RECORD DRAWINGS — August 2011

CORPORATE DWG. NAME: PAVING PLAN

SH 205 & SH 552
ROCKWALL, TEXAS

C6.0

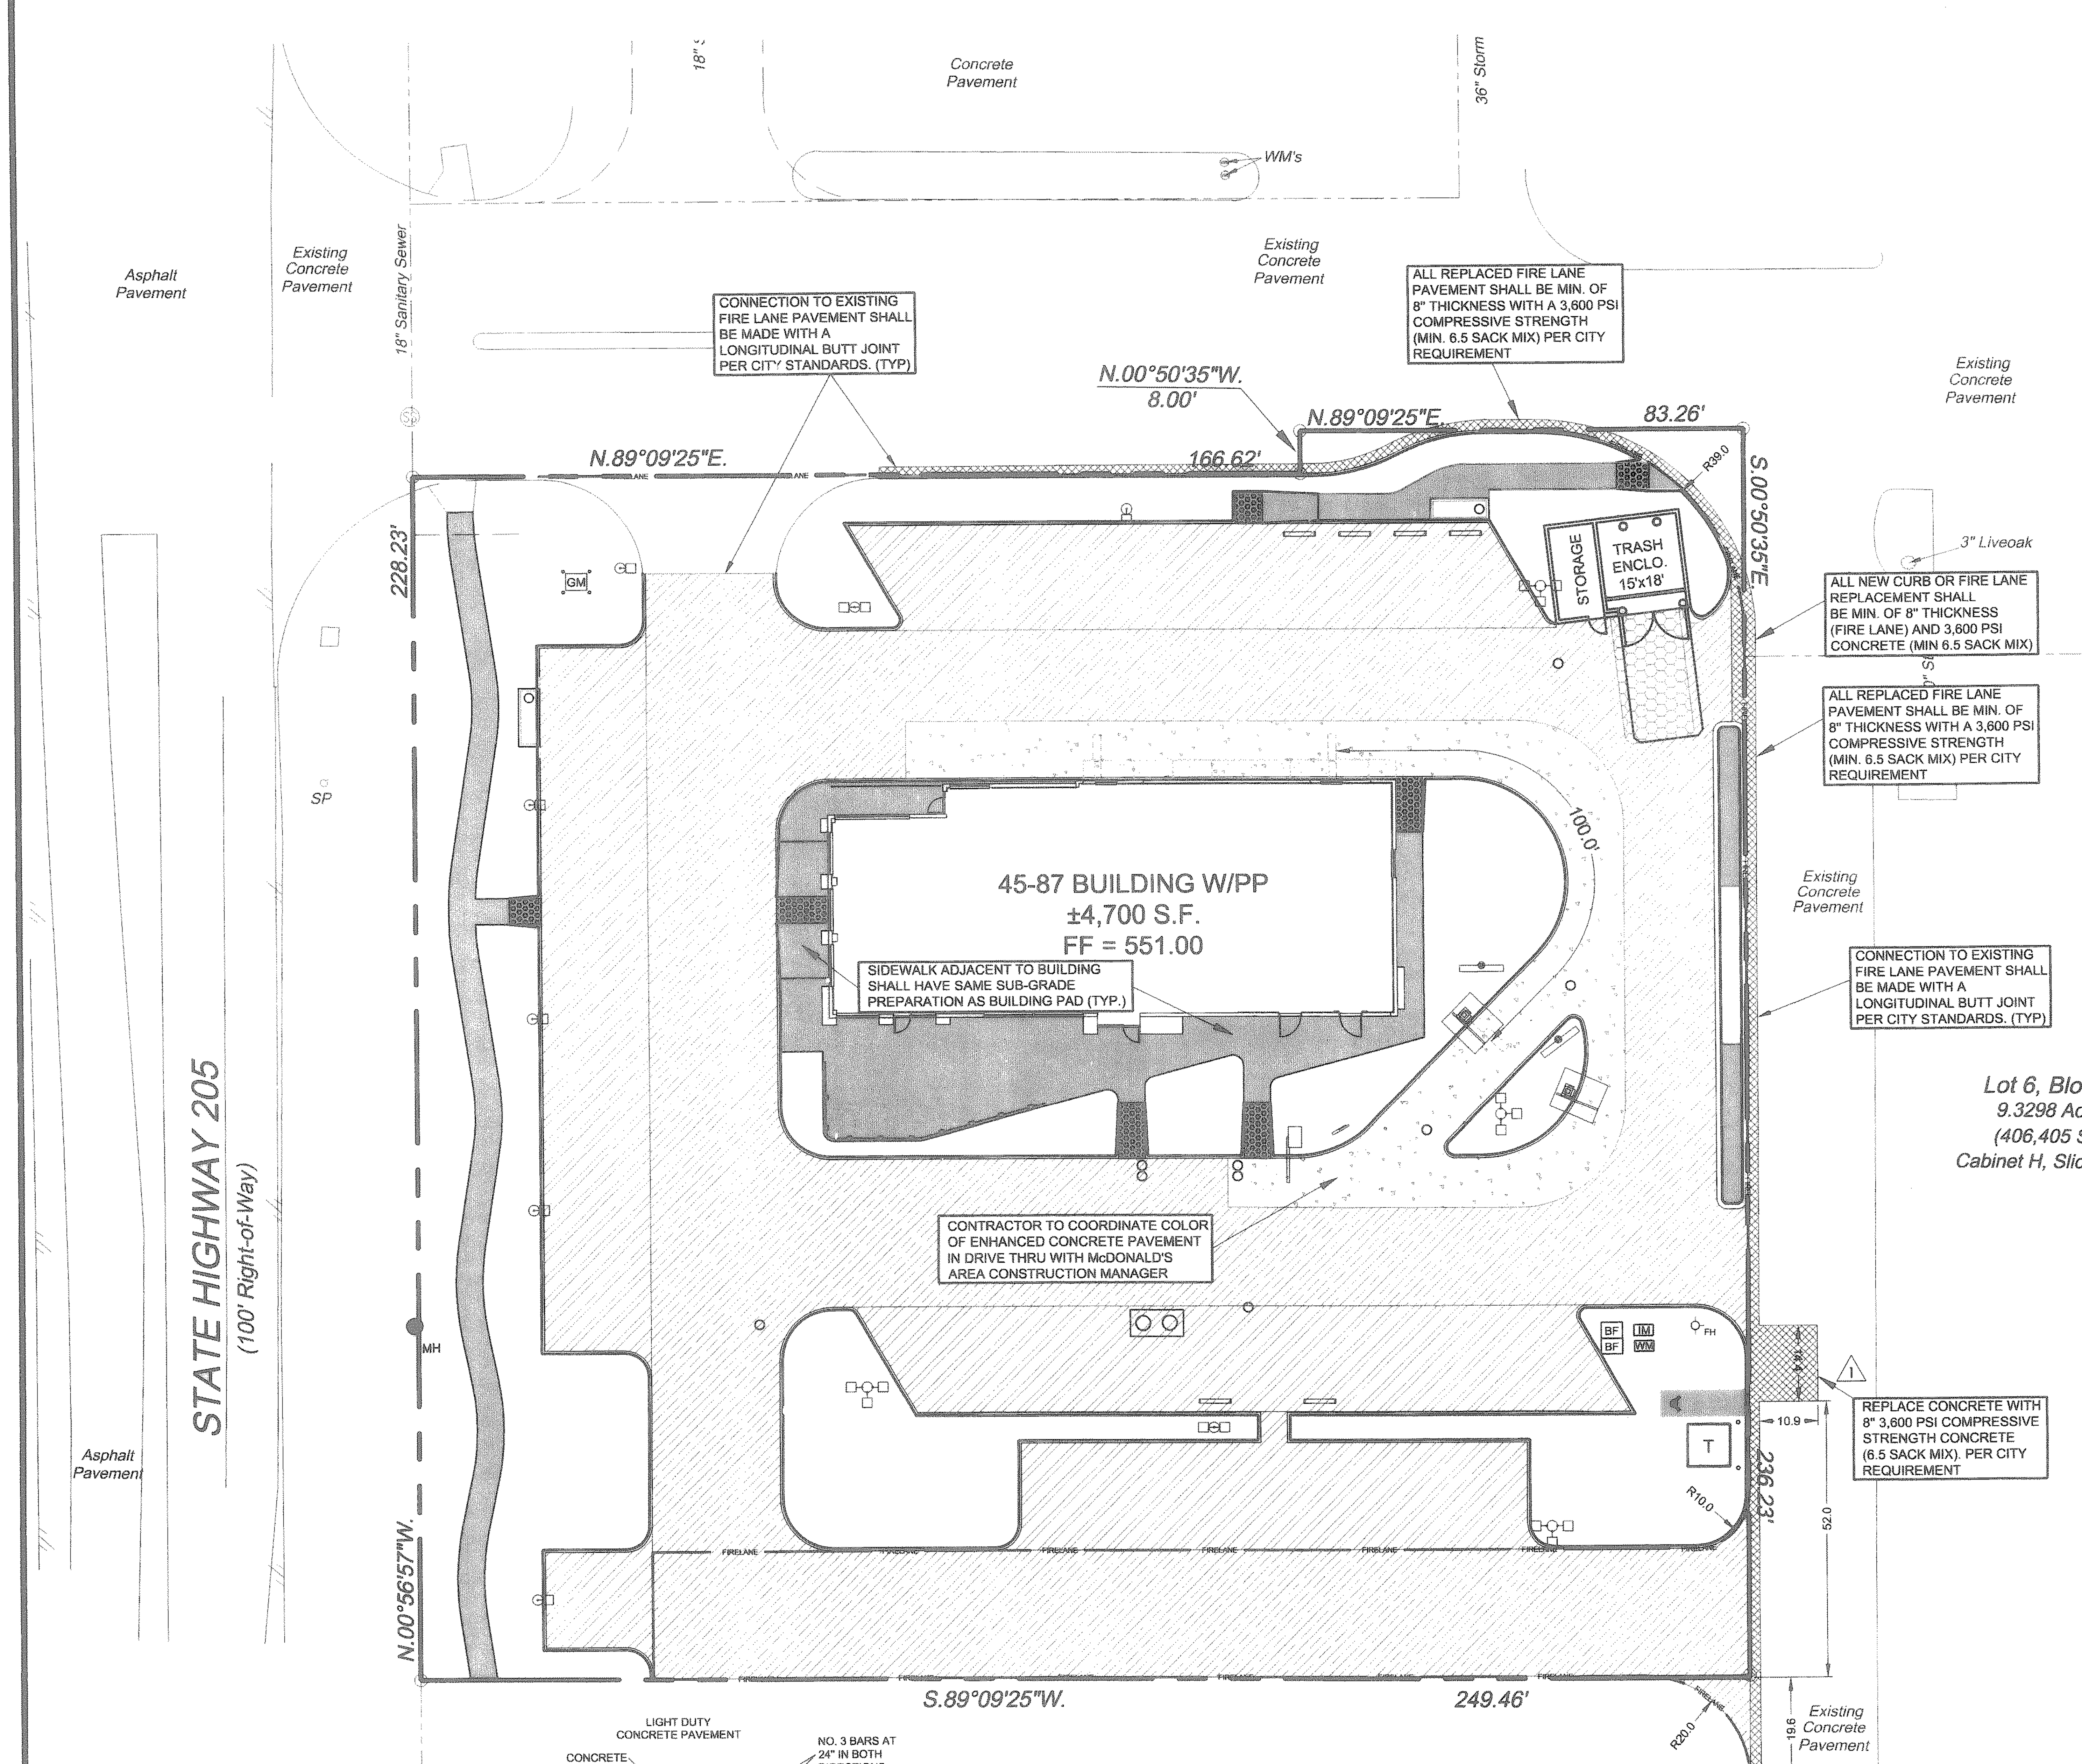
1. ADDED CONCRETE AREA PER UTILITY CONNECTIONS.
2. REVISED PAVING LEGEND.
3. REMOVED ALL SIGNAGE.
4. ADDED NOTE TO NOTES.
5. ADDED PAVEMENT CROSS SECTIONS.

1. CHANGED PAVING PSI TO 3,600 ON 6" MEDIUM, 6" HEAVY, AND 7" INDUSTRIAL DUTY.

1. CREATED ACCESSIBLE PATH TO THE RIGHT OF WAY.
